2006 - 2009 Cadillac XLR XLR-V: Service Bulletin: Slips in Reverse or Third, Delayed Reverse or Drive Engagement

#09-07-30-004J: Slips in Reverse or Third, Delayed Reverse or Drive Engagement, DTC P0776, P2715, P2723, Harsh 2-3 Shifts (Inspect 1-2-3-4 / 3-5-R Housing and Pump Seal Rings) - (Feb 25, 2014)

This bulletin has been revised to update the 2006 - 2009 Vehicles correction

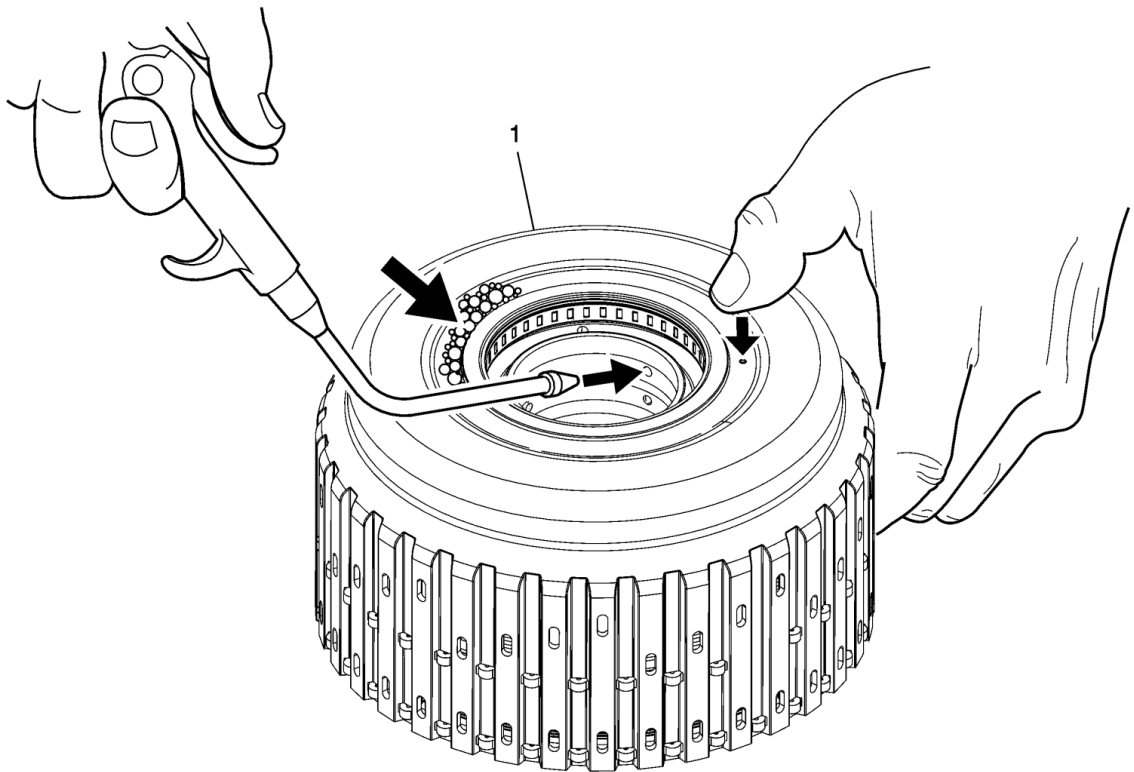
This condition may be caused by a cracked 1-2-3-4 / 3-5-R clutch housing.

Important: If a cracked housing is identified, it must be replaced. Complete, assembled 1-2-3-4 / 3-5-R clutch housings are now available for most applications. These clutch housings come complete with all pistons, seals, clutches, bearing and internal parts. No assembly of the clutch housing is required before it is installed. For applications without a complete, assembled 1-2-3-4 / 3-5-R clutch housing, individual parts must be ordered and the housing assembled in the

Housing Disassembled

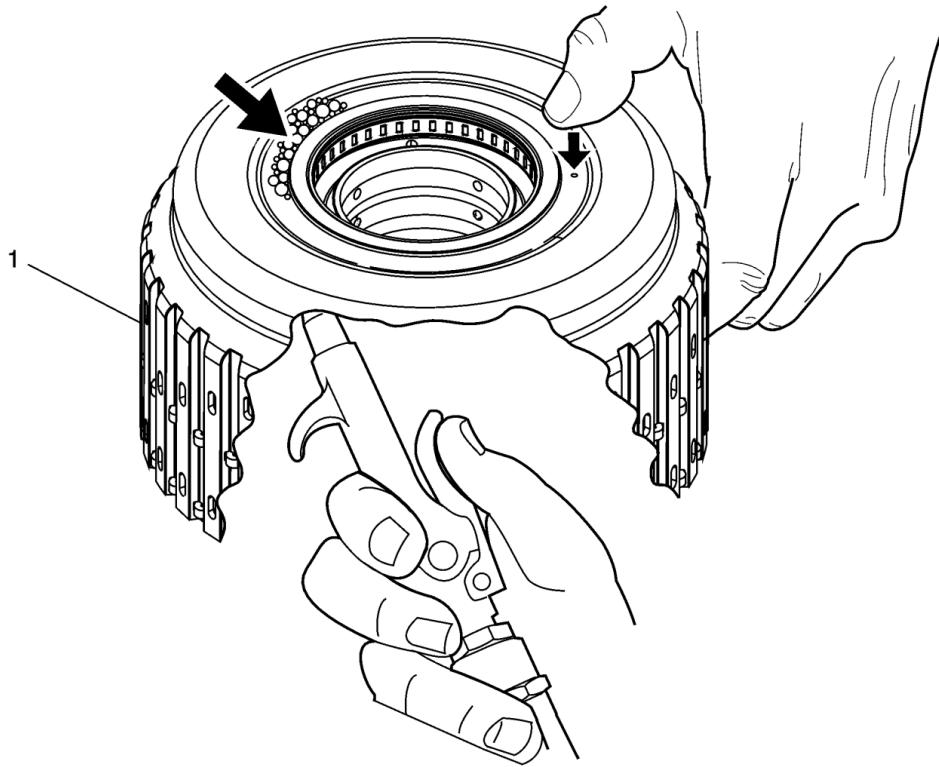
Inspect the 1-2-3-4 / 3-5-R clutch housing for a possible cracked weld.

1. Apply soap compound to weld area of the housing.
2. Hold your thumb over the air bleed passage.
3. Spray compressed air into the housing and inspect the weld area for bubbles.
4. If bubbles are detected, a new housing is required.

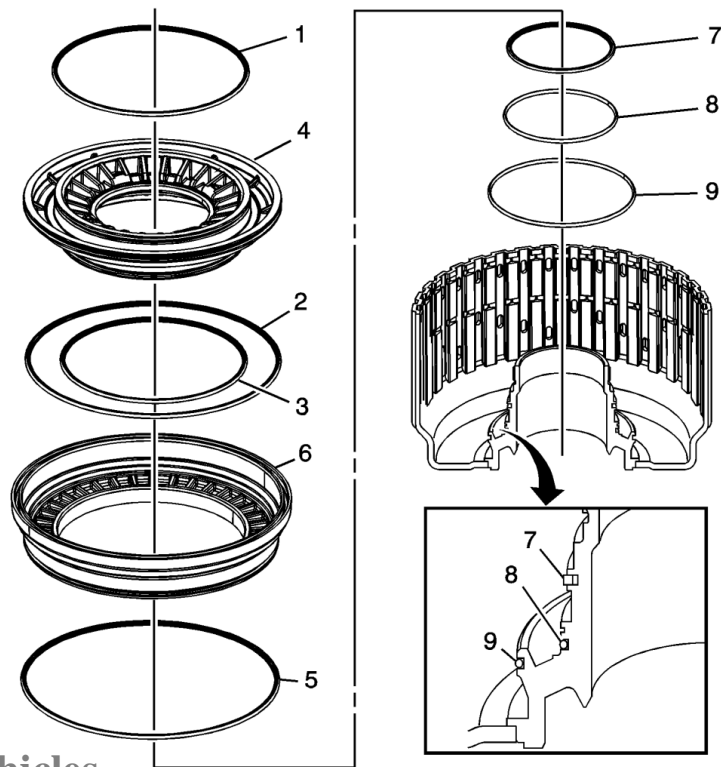
Important: When installing a new 1-2-3-4 / 3-5-R hosing into a 2007 or older 6L80, be sure to install all three (3) inner seals (7, 8, 9 in illustration below). Failure to install these seals can result in no reverse, no forward or distressed clutches.

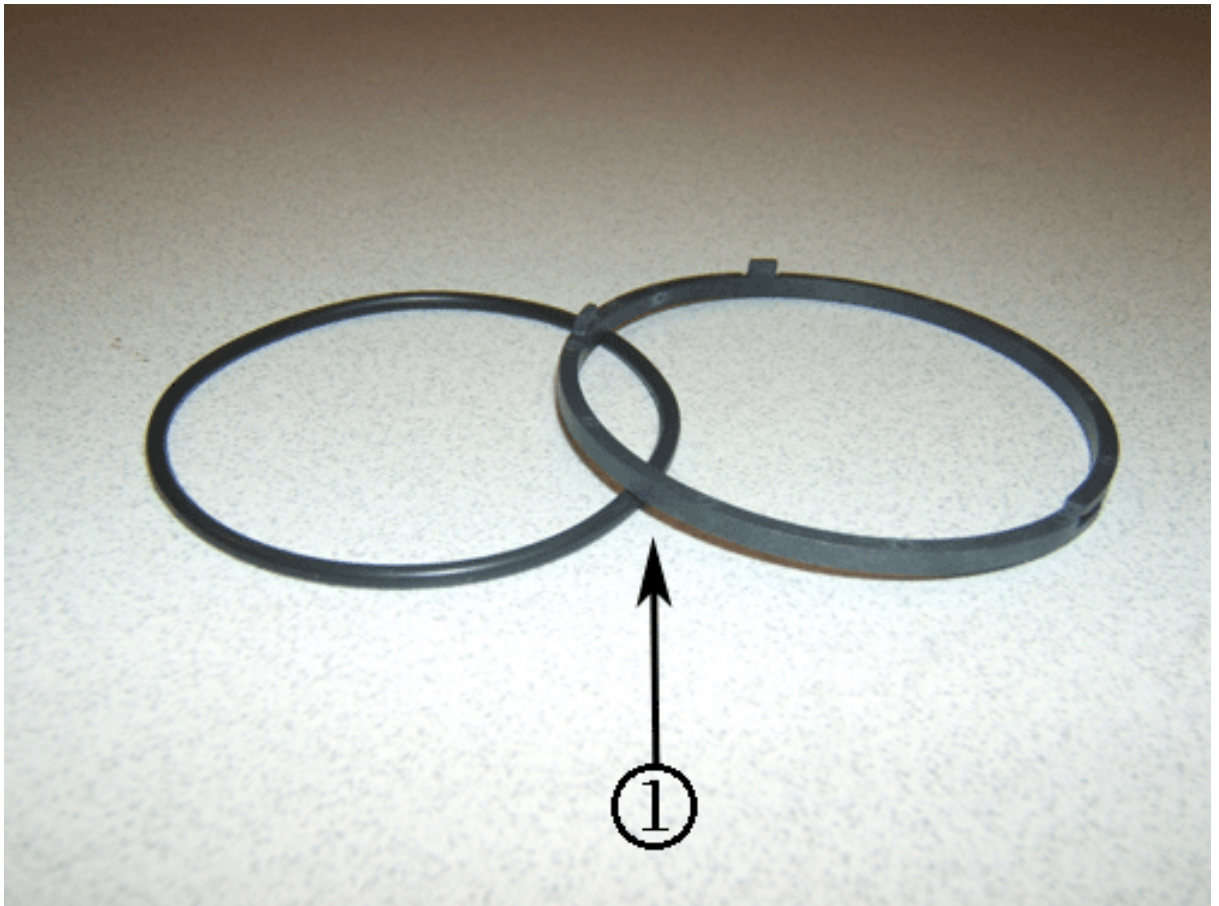
A harsh 2-3 shift condition may be caused by leaking 1-2-3-4 and 3-5-R clutch fluid seal rings (1) on the transmission fluid pump cover assembly.

Inspect the fluid seal rings. Transmissions in 2006, 2007, 2008 and early build 2009 models used a 1- piece design seal ring in production. Starting December 2008, a 2-piece seal ring design was implemented. The 1-piece seal ring design may cause a harsh 2-3 shift due to leakage. This is typically a low mileage issue. If the seal rings are a 1-piece design they should be replaced with new 1-piece design seal rings. It is not necessary to replace the pump cover.

Notice: The clutch fluid seal rings must be installed in a specific way. Failure to install new clutch fluid seal rings in the proper orientation may cause a repeat harsh 2-3 shift. Refer to 1-2-3-4 and 3-5 Reverse Clutch Fluid Seal Ring Installation (6L80/90) in SI for correct installation.

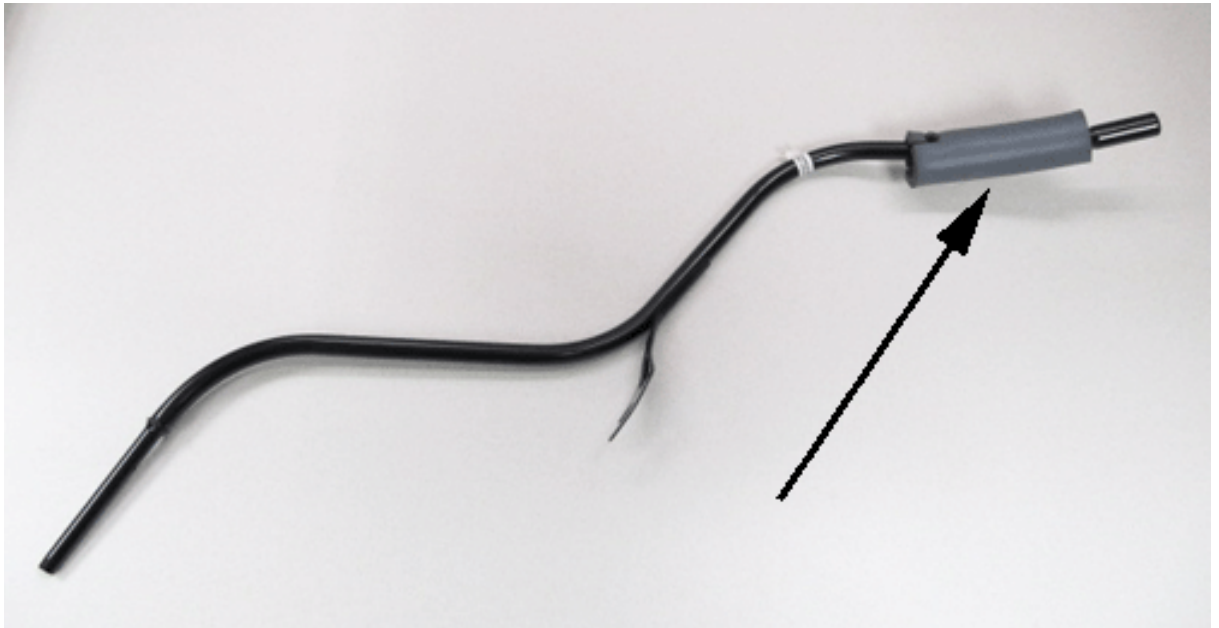
If the seals are the 2-piece design shown below, they do not need to be replaced unless they are worn or damaged.

Important: Do not install 1-piece design seal rings on a 2-piece seal

ring design pump cover. The 2-piece seal ring design pump cover can be identified by the notch in the seal ring grooves that accepts the tab on the 2-piece design seal rings.
